Model: PRIPORT HP4-R2.5	Date: 13-Jan-09	No.: RC272001g
-------------------------	-----------------	----------------

Subject: Firmware Release History – HP4-R2.5		Prepared by: H. Matsui	
From: 1st Overseas Tech Support Sec., 1st PQM Dept.			
Classification:	<input type="checkbox"/> Troubleshooting <input type="checkbox"/> Mechanical <input type="checkbox"/> Paper path <input type="checkbox"/> Product Safety	<input type="checkbox"/> Part information <input type="checkbox"/> Electrical <input type="checkbox"/> Transmit/receive <input checked="" type="checkbox"/> Other ()	<input type="checkbox"/> Action required <input type="checkbox"/> Service manual revision <input type="checkbox"/> Retrofit information <input type="checkbox"/> Tier 2

Model: PRIPORT HQPG4-R2.5		Date: 12-Feb-09	No.: RC272002
Subject: Energy Saver Mode		Prepared by: K. Yamamoto	
From: 2nd Tech Support Sec. Service Support Dept.			
Classification:	<input checked="" type="checkbox"/> Troubleshooting	<input type="checkbox"/> Part information	<input type="checkbox"/> Action required
	<input type="checkbox"/> Mechanical	<input type="checkbox"/> Electrical	<input type="checkbox"/> Service manual revision
	<input type="chec

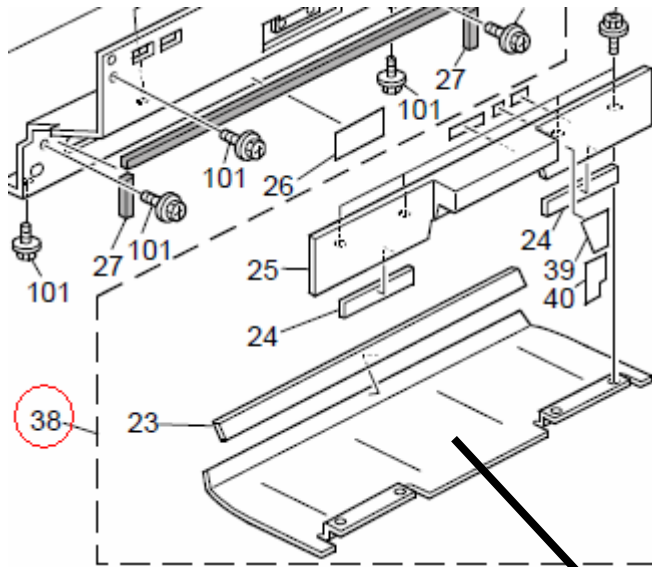
Sometimes, the master vibrates as suction is holding it against the duct of the master making unit.

A cushion was added to the duct, which reduces the sound.

Note: This cushion was added to service part P/N C2642188 (index #38), as shown in the illustration below.

Old part number	New part number	Description	Q'ty	Int	Page	Index	Note
-	C2722248	Cushion: Duct: Scraper	1	-	29*	43*

11.Plotter Unit 3 (C272/C273)

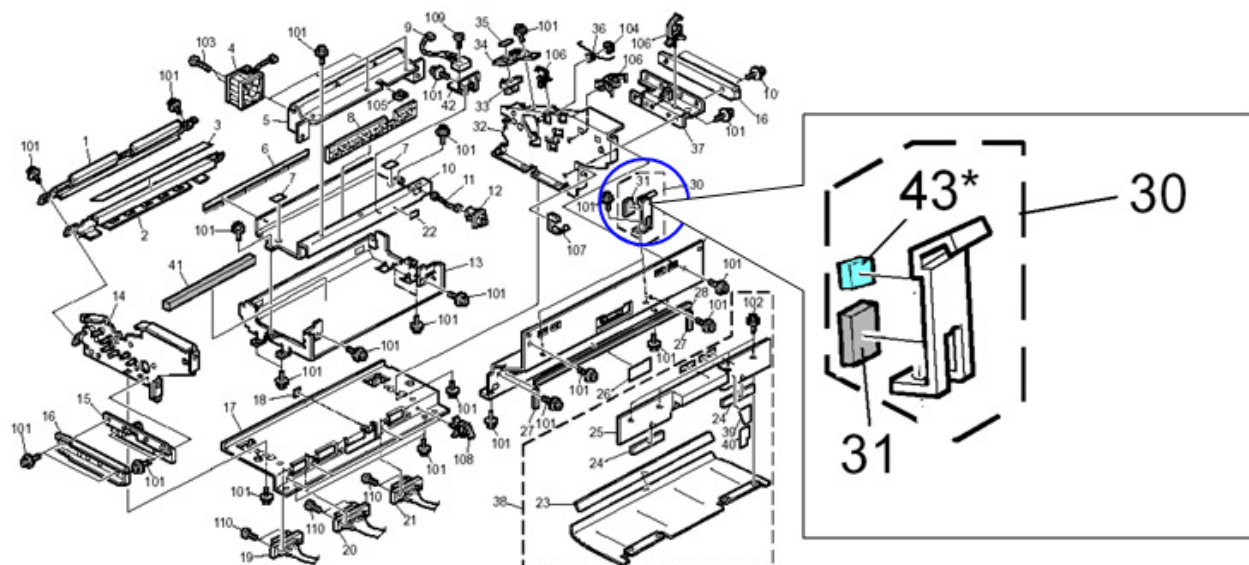
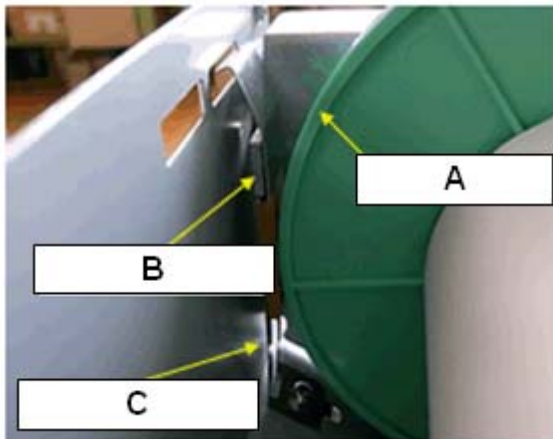
Change: Anti-vibration weights were added to the brake shoe.

Reason: To prevent a squeaking sound from being generated in the plotter unit.

New part number	Description	Q'ty	Int	Page	Index	Note
C2722230	PLATE:BRACKET SHOE:PLOTTER:ASS'Y	0-2	X/O	29	43*

**A:** Master flange**B:** Anti-vibration weight (**C2722230 / Index 43**)**C:** Brake shoe

Important notes regarding attachment

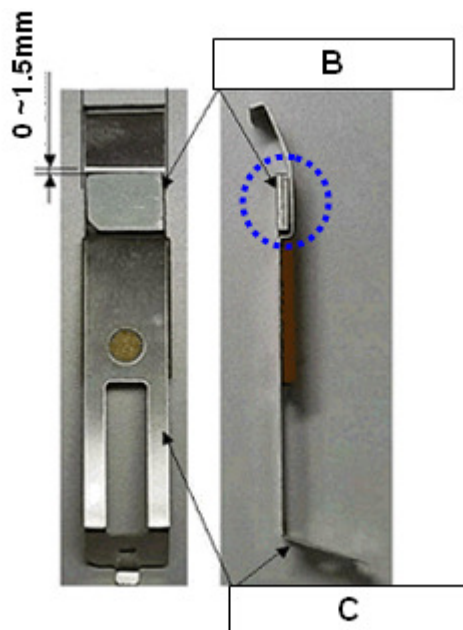
- Before you attach B to C, remove the grease on the surface of C.
- Attach B to C with the following clearances:
 - Lengthwise: 0–1.5mm of the bend in C
 - Side to side: Line up the side edges of both B and C

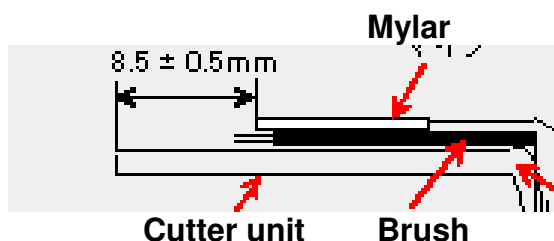
Change: An anti-static brush was added.

Reason: To improve master feeding performance.

Old part number	New part number	Description	Q'ty	Int	Page	Index
C2722070	C2722071	CUTTER UNIT:ASS'Y	1	X/0	25	42
C2492219	C2722219	BLADE:CUTTER UNIT	4	X/0 as	25	43
-	C2722220	DISCHARGE BRUSH:CUTTER UNIT:PLOTTER	4	a set	25	53*

1. Remove the Mylar before you attach the new brush.
2. Clean the cutter unit before attaching the new Mylar and brush.
3. Attach the brush first, and then the Mylar.
